City of Ketchum

CITY COUNCIL MEETING AGENDA MEMO

I move to approve Lot Consolidation Preliminary Plat & Waiver Application File No. P22-042A subject to conditions 1 through 3.

Application File No. P22-042A

LOT 7A, BLOCK 91,
KETCHUM TOWNSITE

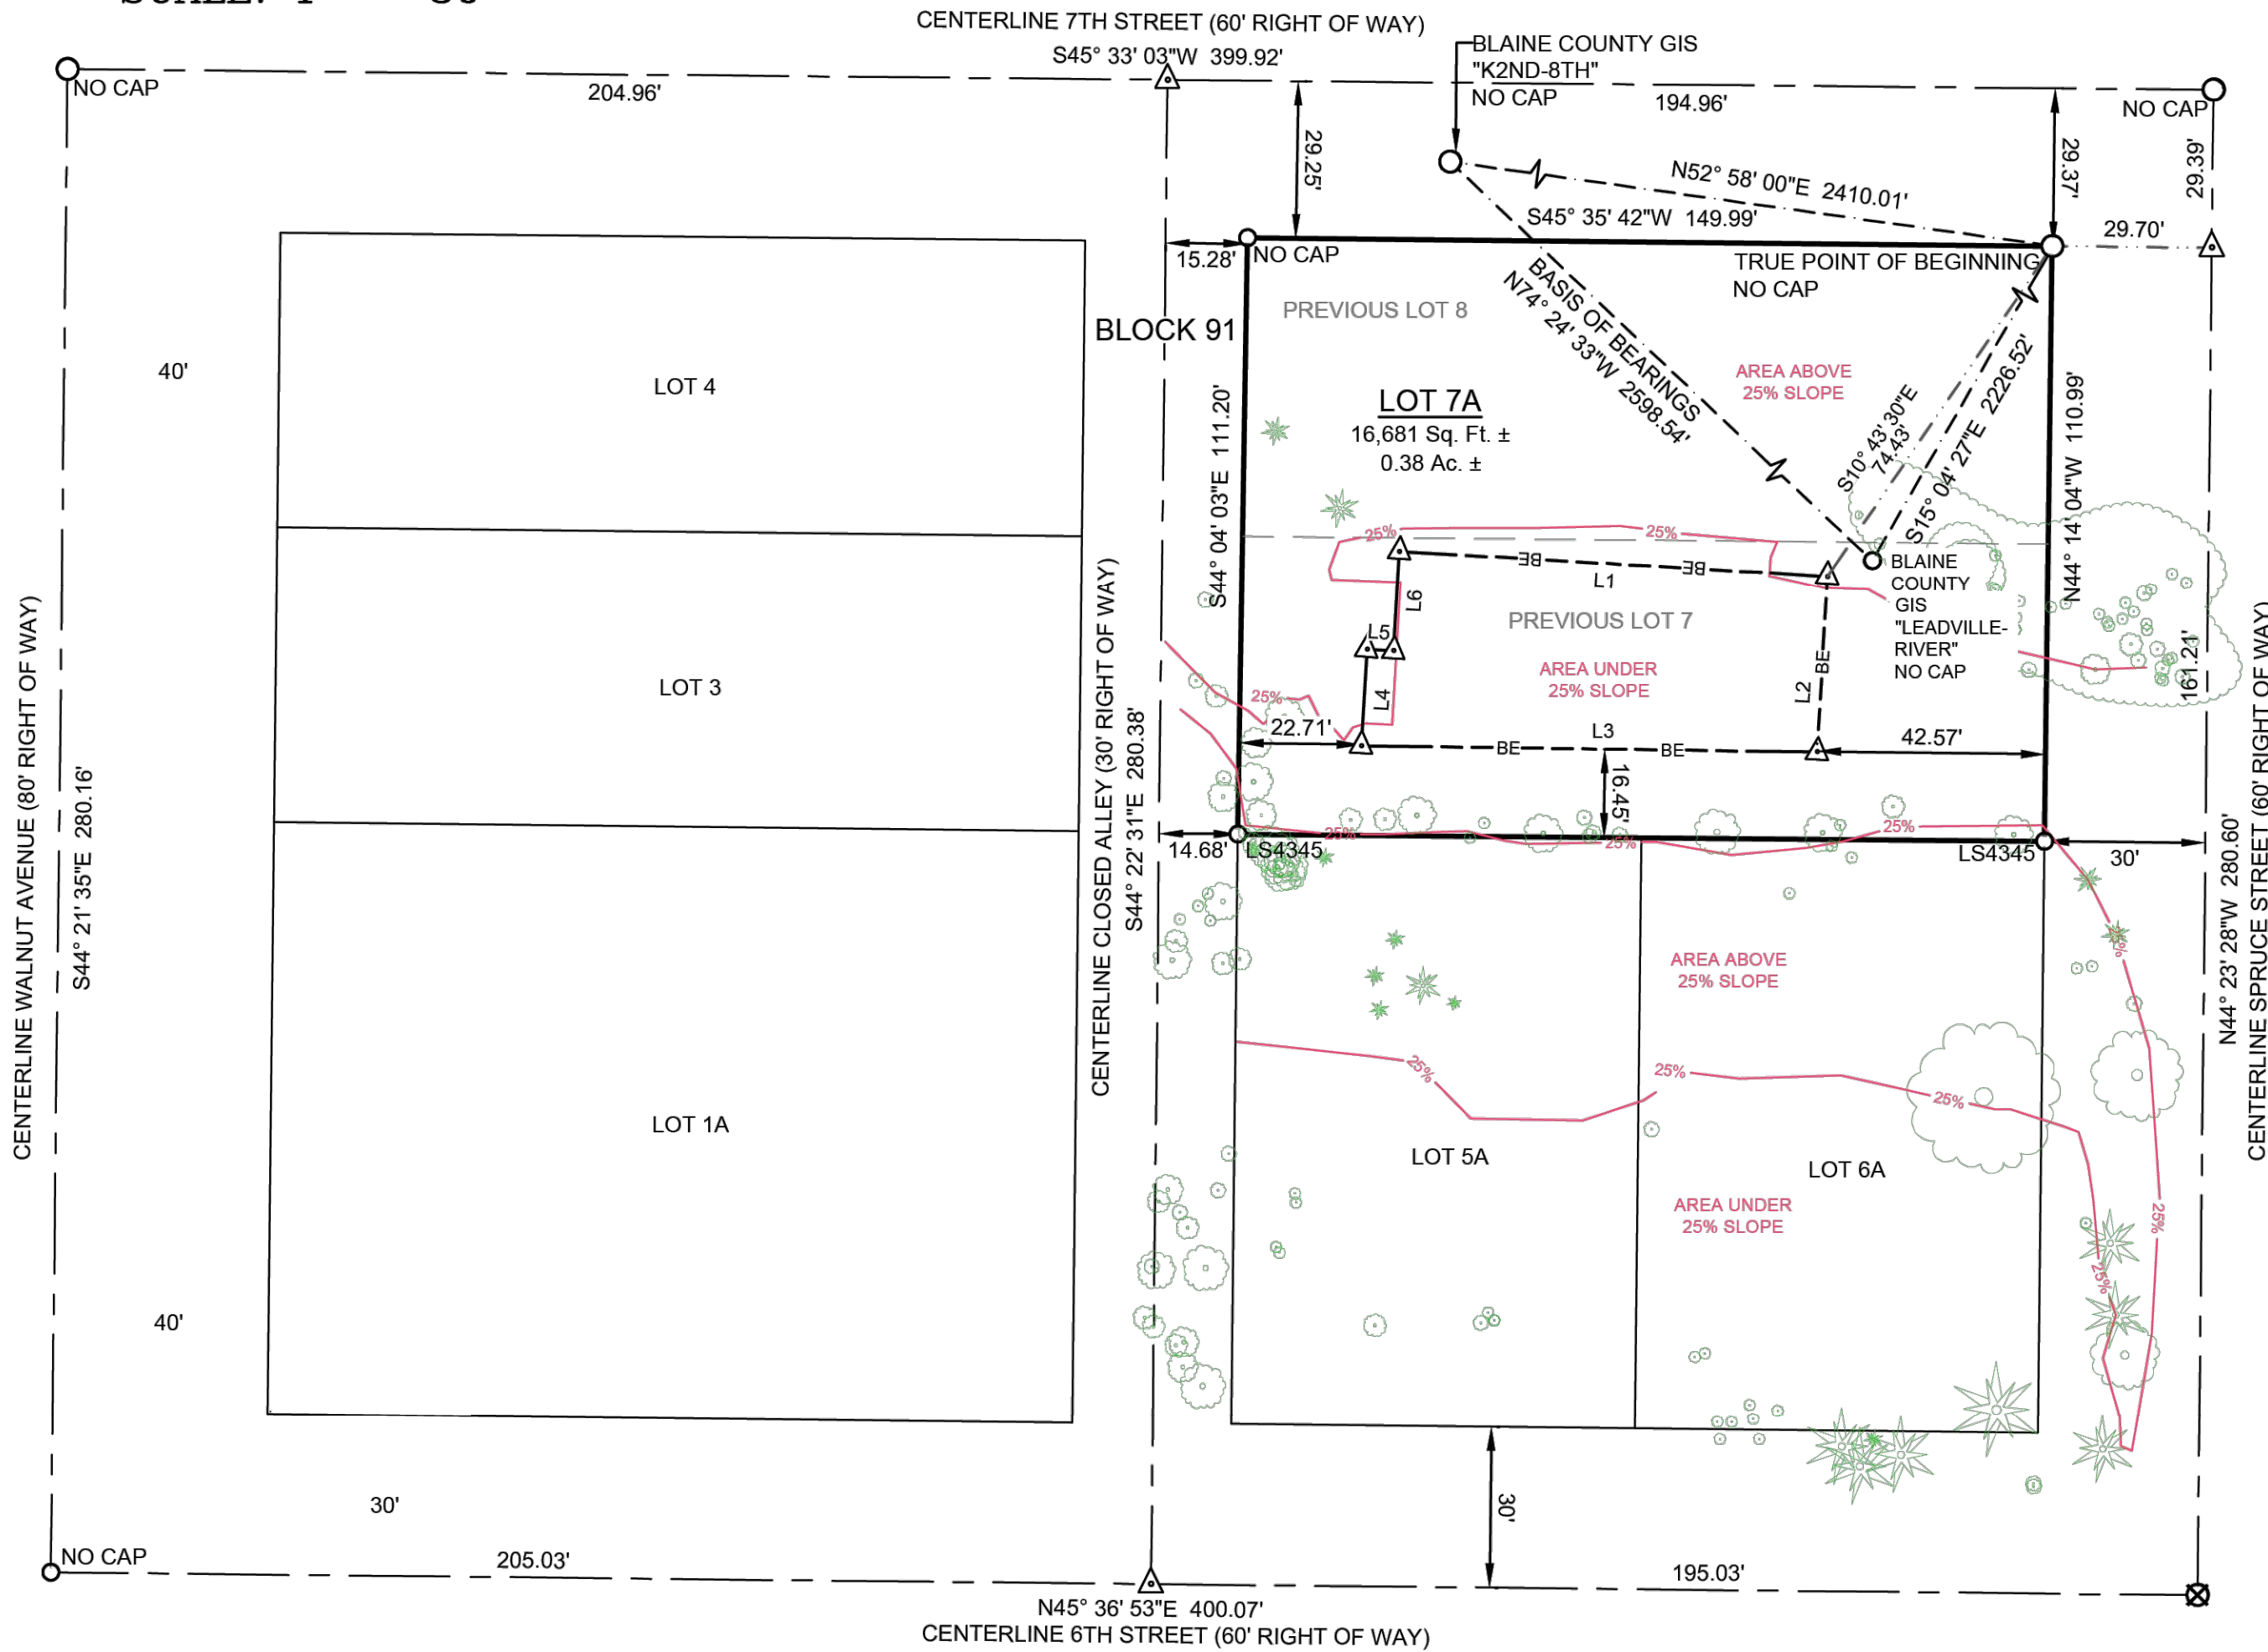
<i>Findings</i>	<i>The name of the owner and surveyor is shown on Sheet 1 of the plat. The plat was prepared by Mark E. Phillips of Galena Engineering.</i>
<input checked="" type="checkbox"/>	<input type="checkbox"/>	<input type="checkbox"/>	16.04.030.J.4	Legal description of the area platted.
			<i>Findings</i>	<i>The legal description of the area platted is shown on page 1 of the preliminary plat.</i>
<input checked="" type="checkbox"/>	<input type="checkbox"/>	<input type="checkbox"/>	16.04.030.J.5	The names and the intersecting boundary lines of adjoining subdivisions and parcels of property.
			<i>Findings</i>	<i>The preliminary plat shows adjacent lots 1A, 3, 4, 5A, and 6A located within block 91 of the original Ketchum Townsite.</i>
<input checked="" type="checkbox"/>	<input type="checkbox"/>	<input type="checkbox"/>	16.04.030.J.6	A contour map of the subdivision with contour lines and a maximum interval of five feet (5') to show the configuration of the land based upon the United States geodetic survey data, or other data approved by the city engineer.

<input checked="" type="checkbox"/>	<input type="checkbox"/>	<input type="checkbox"/>	16.04.030.J.9	Existing zoning of the tract.
			Findings	<i>Plat note #5 on Sheet 1 of the preliminary plat specifies that the subject property is located within the City's Limited Residential Zoning District.</i>
<input checked="" type="checkbox"/>	<input type="checkbox"/>	<input type="checkbox"/>	16.04.030.J.10	The proposed location of street rights of way, lots, and lot lines, easements, including all approximate dimensions, and including all proposed lot and block numbering and proposed street names.
			Findings	<i>The preliminary plat shows the location and property lines for consolidated Lot 7A. No new streets or blocks are being proposed with this application.</i>
<input type="checkbox"/>	<input type="checkbox"/>	<input checked="" type="checkbox"/>	16.04.030.J.11	The location, approximate size and proposed use of all land intended to be dedicated for public use or for common use of all future property owners within the proposed subdivision.

<i>Findings</i>	<i>Sheet 1 of the preliminary plat shows existing conifer and deciduous trees.</i>
<input checked="" type="checkbox"/>	<input type="checkbox"/>	<input type="checkbox"/>	16.04.030.J.22	A current title report shall be provided at the time that the preliminary plat is filed with the administrator, together with a copy of the owner's recorded deed to such property.
			<i>Findings</i>	<i>The applicant submitted a title commitment issued by Sun Valley Title Company, and a quitclaim deed recorded at Instrument Number 675673 with the preliminary plat application.</i>
<input checked="" type="checkbox"/>	<input type="checkbox"/>	<input type="checkbox"/>	16.04.030.J.23	Three (3) copies of the preliminary plat shall be filed with the administrator.
			<i>Findings</i>	<i>The City of Ketchum received digital copies of the preliminary plat at the time of application.</i>
